1 **REFERENCE: Chapter 2: Manitoba's Preferred Development Plan Facilities; Section:**
2 **2.1.3.3; Page No.: 26**

4 **PREAMBLE:** Manitoba Hydro has stated the following: "Integral to the process was
5 public involvement. Two rounds of public engagement were conducted for the Keeyask
6 Transmission Project to gather public comments on preliminary siting and routing
7 choices, and Manitoba Hydro funded self-directed studies undertaken by TCN, FLCN and
8 the Manitoba Metis Federation."

Figure 1. EMERGENCY ENERGY AVAILABLE
EXCLUDING NON-FIRM ON-PEAK IMPORTS

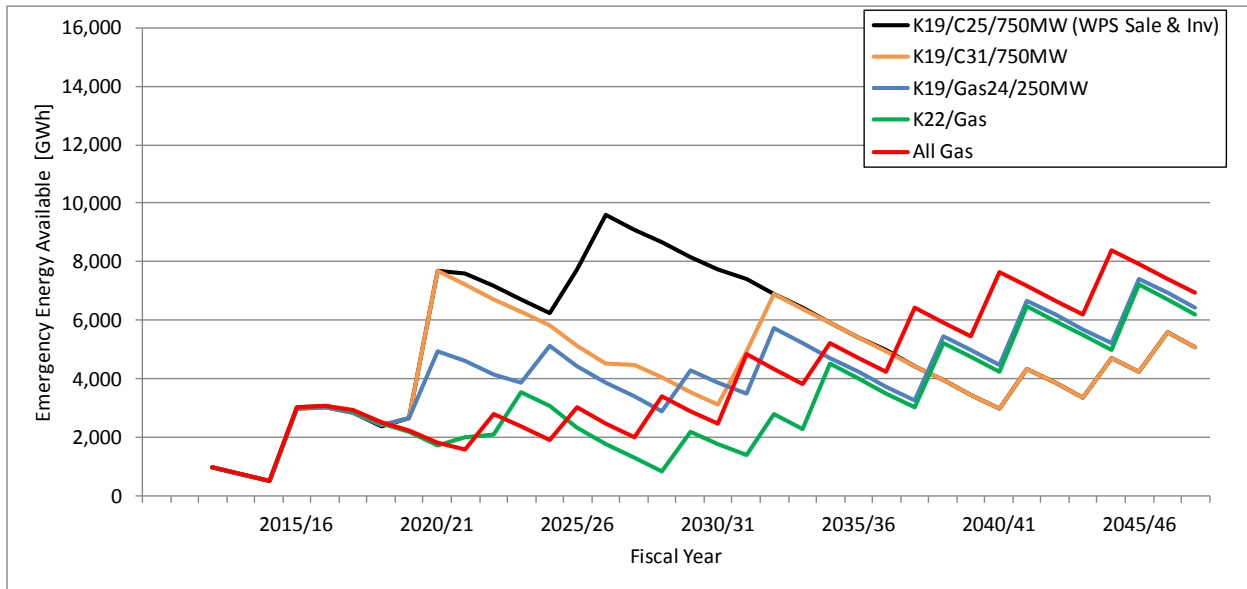
5 The Preferred Development Plan offers customers more security against the risks of extreme
6 drought. What is the expected probability of extreme drought included in the MA-BCA and to
7 what extent have climate change impacts been considered in the future probability?

- 1 The attached document provides further detailed quantification and comparison of the
- 2 emergency energy additional to dependable energy that is associated with certain key
- 3 development plans.

Figure 1 shows that, when the non-firm on-peak imports are excluded, the plan with Conawapa G.S. in 2031/32 provides, over the 20 year period starting with the 2019/20 Keeyask G.S. in-service date, an average of between approximately 1,000 GWh/year and 2,500 GWh/year more emergency energy compared to the All Gas, K22/Gas and K19/Gas24/250MW Plans. Alternatively when Conawapa is advanced in the Preferred Plan this range grows to average between approximately 2,500 GWh/year and 4,000 GWh/year.
